Re: Supplemental Filings for Pending Special Permits/Site Plan Application  
164 Grove Street, Franklin, MA

**Re: 164 Grove Street  
Site Plan Peer Review Update**

We have received the peer review letter from BETA Group, Inc. dated September 24, 2020 in regards to the revised documents for the proposed Site Plan Approval application, "**Permit Site Development Plans - 164 Grove Street, Franklin, Massachusetts**" and offer the following responses.

**SUBSURFACE INFILTRATION FACILITY DETAIL (PSIS-1)**  
(NOT TO SCALE)

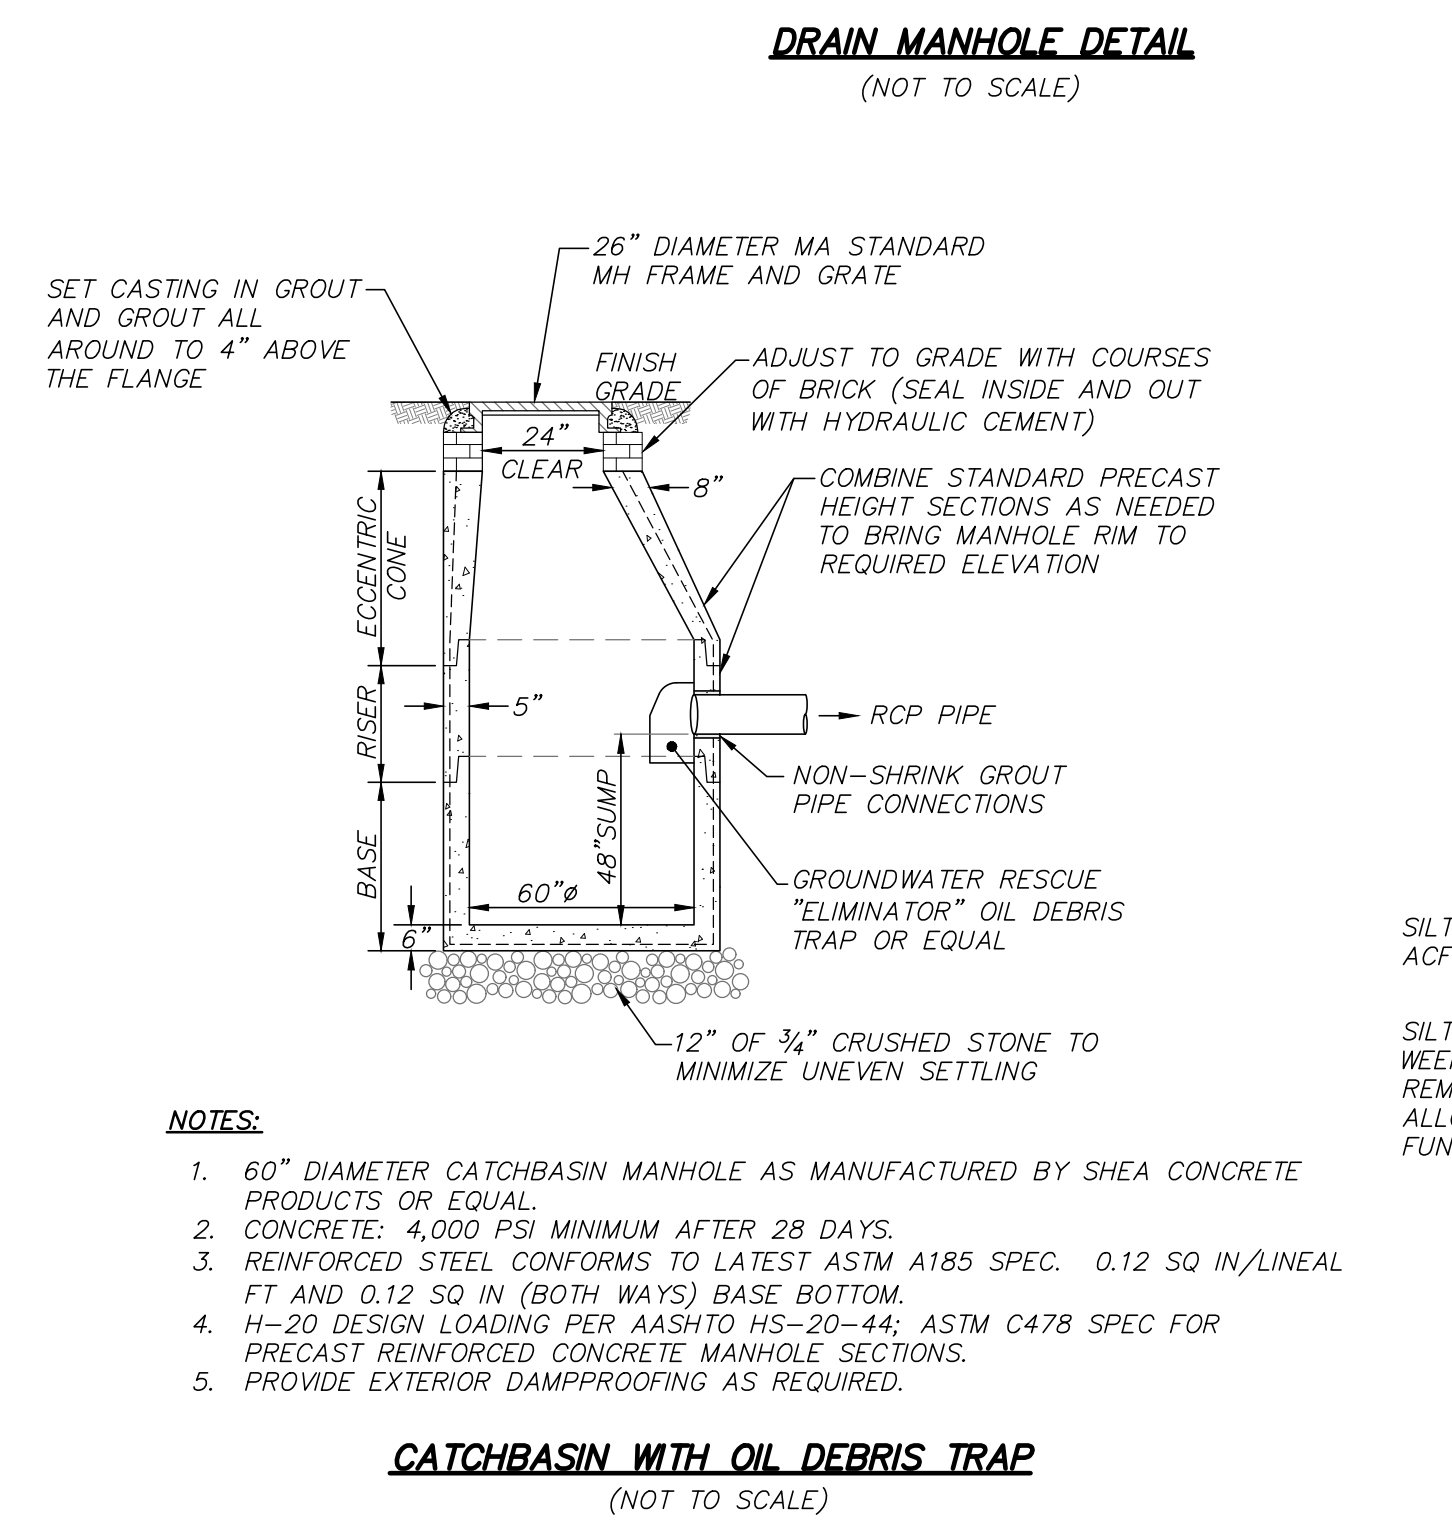
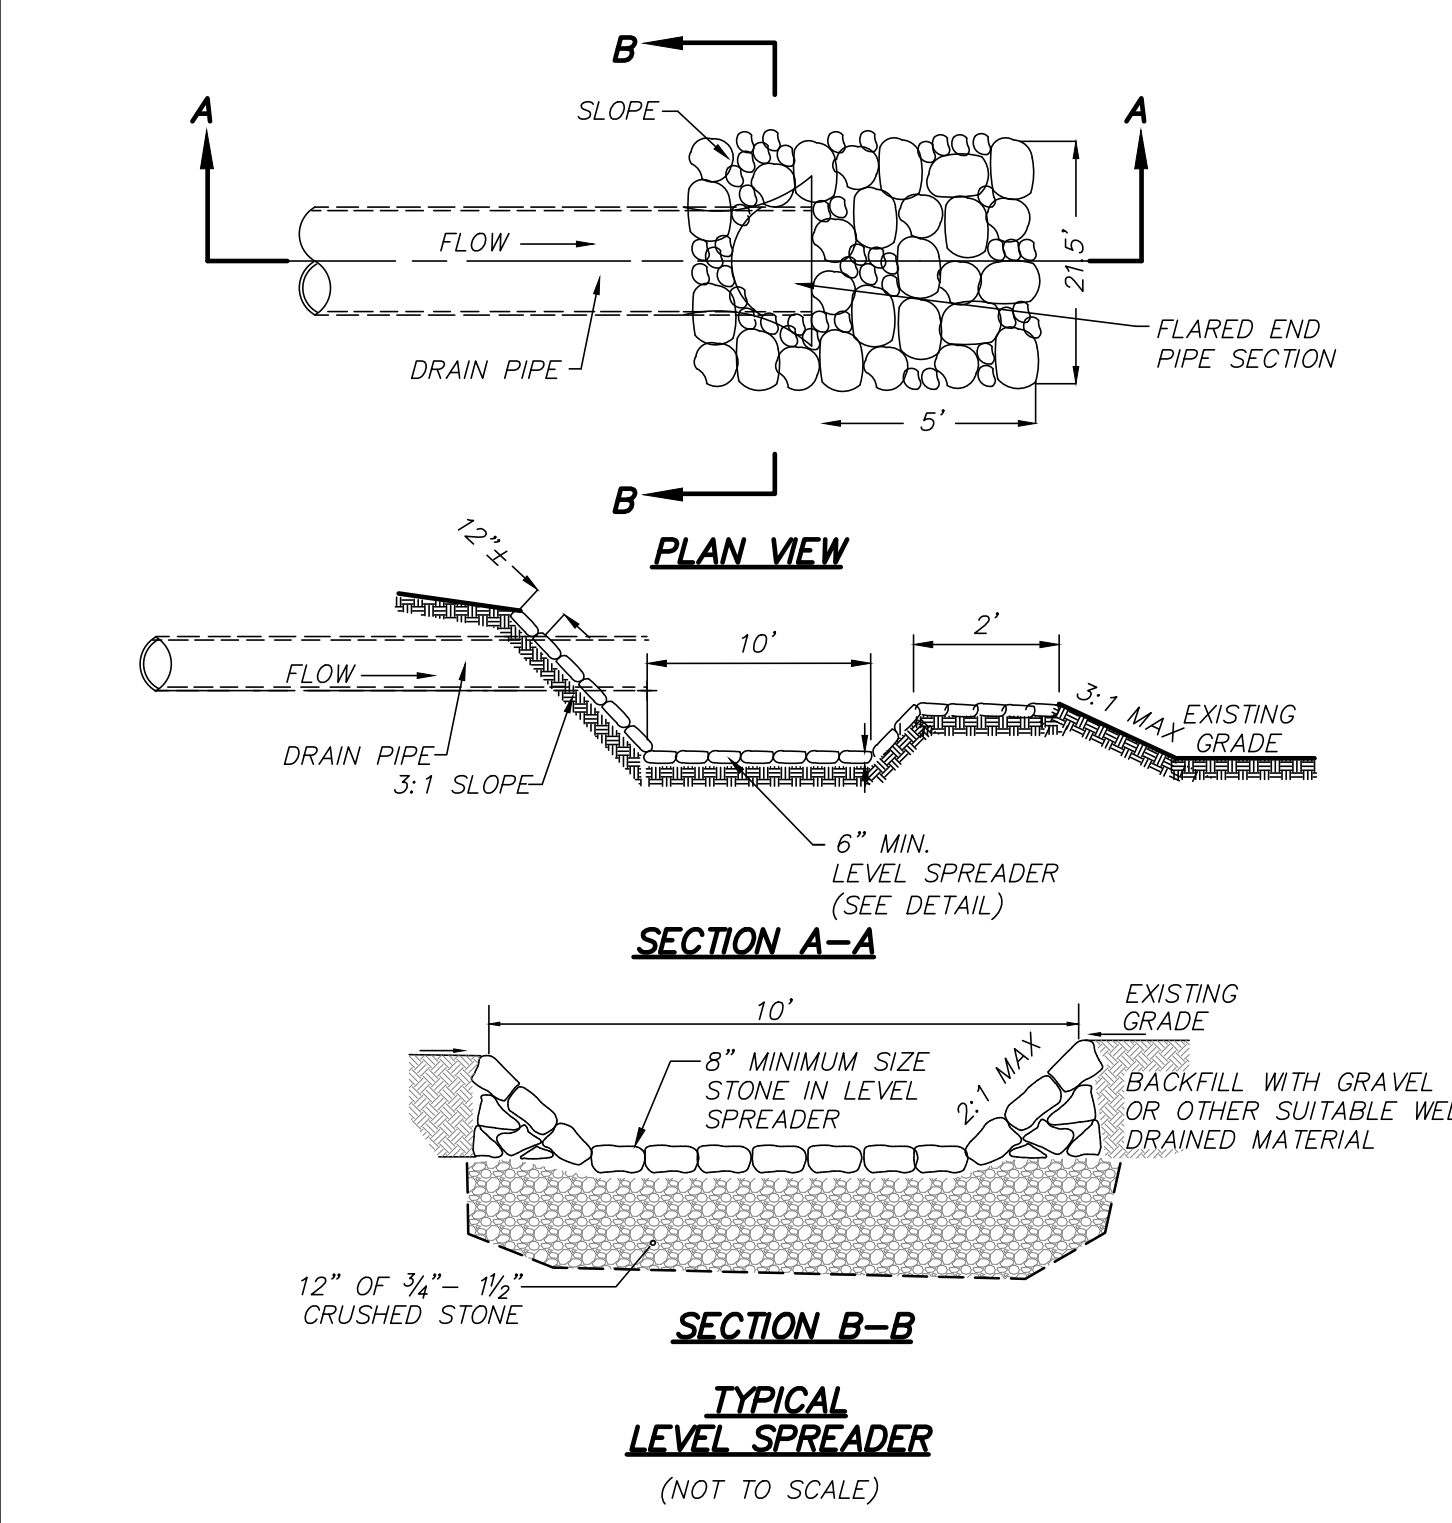
SW16. Clarify the Schematic Plan View of the Subsurface Infiltration Facility Details to indicate it is a typical layout and the dimensions are 20 rows of 11 chambers. Revise detail name, as necessary, to reflect the number of systems proposed. *MAI: The details of the Subsurface Infiltration Facility details have been revised accordingly, refer to Sheet C 5.0. BETA2: Details revised – issue resolved.*

SW18. Revise the top elevation of the stone in the infiltration system on the Cross-Section detail to be consistent with other elevations. *MAI: The top elevation of the stone in the infiltration system has been revised accordingly, refer to Sheet C 5.0.* **BETA2: Elevation revised – issue resolved.**
